Fitting R1290 & R1291 Sliding Mechanisms into Standard ABS Rack Cases

6U Case

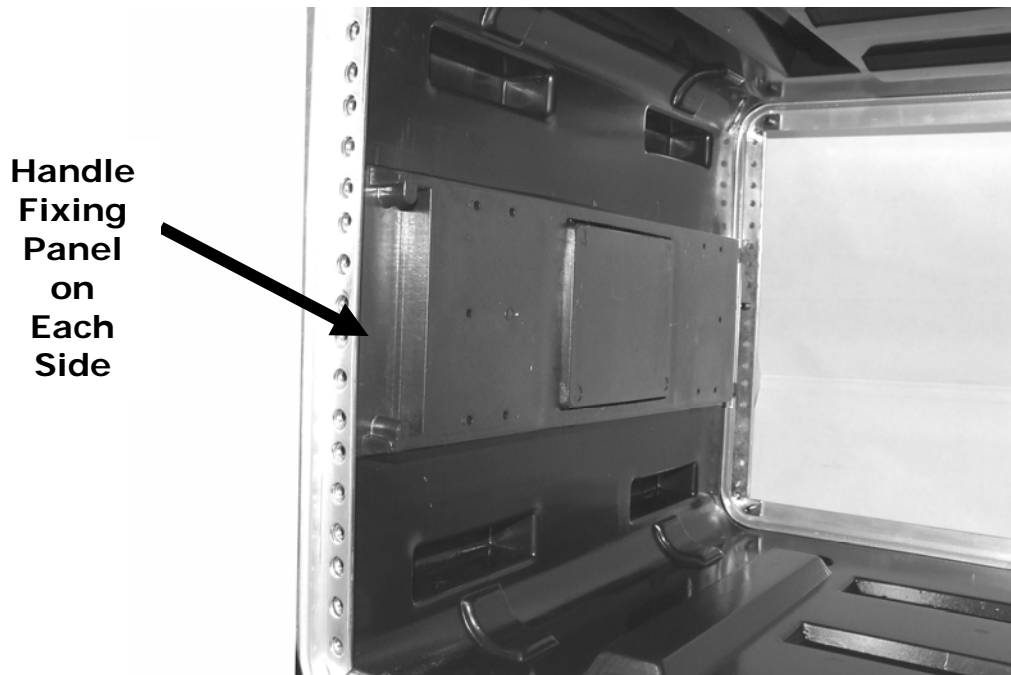
Most standard ABS Racks from 4U up have an internal panels that obstruct the fitting of any Penn R1290 & R1291 sliding units within the middle of the case.

What stops this application are the 4 adjustment fittings currently being used. Change these for M4 x 8mm PH screw with an M4 Serrated Flange Head nut - The problem goes away. THE OTHER BENEFIT IS THAT THE ADJUSTMENT OF THE MOUNTING EARS CAN BE NOW BE DONE WITH JUST A SCREW DRIVER
